UNITED STATES PATENT AND TRADEMARK OFFICE

10/549,720

Office Action Summary	Application No. 10/549,720	Applicant(s) WEIBERLE ET AL.	
	Examiner Melody M. Burch	Art Unit 3657

DETAILED ACTION

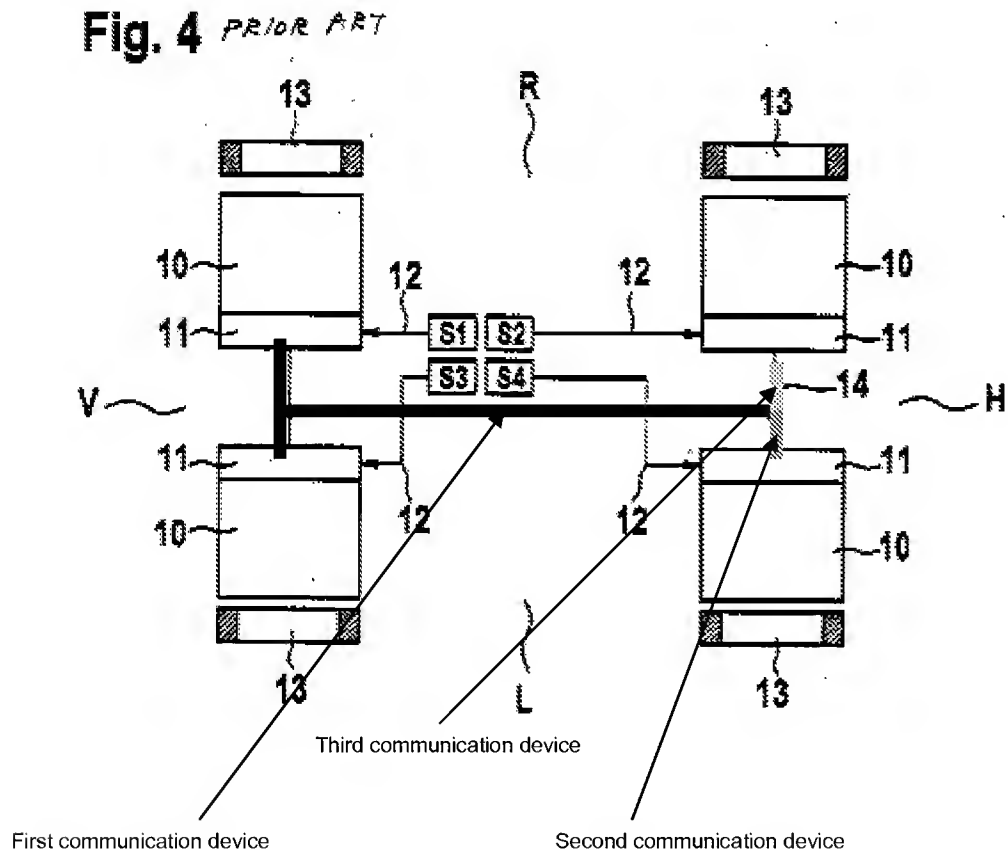
Re: claims 9, 13, 14, 15, and 16. Admitted Prior Art figure 4 shows a decentralized electrical braking system comprising: at least four sensors S1-S4 for sensing an actuation of a brake actuating device; at least four wheel-braking modules 10, each wheel-braking module being assigned to a corresponding vehicle wheel and acquiring sensor data and controlling braking of the corresponding vehicle wheel; at least one first communication device as labeled on page 9 of the instant Office action connecting all four wheel-braking modules to one another by connecting to the labeled

second and third communication devices for exchange of data; an electrical connecting device 12 for connecting each sensor to at least one wheel-braking module; and at least one of a second communication device as labeled and a third communication device as labeled for facilitating at least one of receiving and exchanging data between at least two wheel-braking modules associated with opposite lateral sides of the vehicle, wherein the first, second and third communication devices are parts of the system, wherein a front wheel braking module of a first lateral side of the vehicle (upper left element 10) being connected only to a rear wheel braking module of a second lateral side of the vehicle (lower right element 10) by the second communication device via the first communication device and a front wheel braking module of the second lateral side (lower left element 10) of the vehicle being connected only to a rear wheel braking module of the first lateral side of the vehicle (upper right element 10) by the third communication device via the first communication device.

Admitted Prior Art figure 4 shows communication device parts meeting at a junction but is silent with regard to the first second and third communication devices being discrete.

It would have been obvious to one of ordinary skill in the art at the time the invention was made to have modified the first, second, and third communication devices of Admitted Prior Art figure 4 to have been discrete components, as taught by Kempf, in

order to provide separate elements that facilitate system repair by enabling only a discrete component to be replaced instead of the entire communication system.

Re: claims 10 and 12. Admitted Prior Art figure 4, as modified, teaches in prior art figure 4 the limitation wherein the at least one of the second communication device and the third communication device is configured identically to the first communication device in the form of a cable/wire, and each sensor is connected to two wheel braking modules associated with opposite lateral sides of the vehicle on the same axle via intervening elements such as portions of the communication devices.
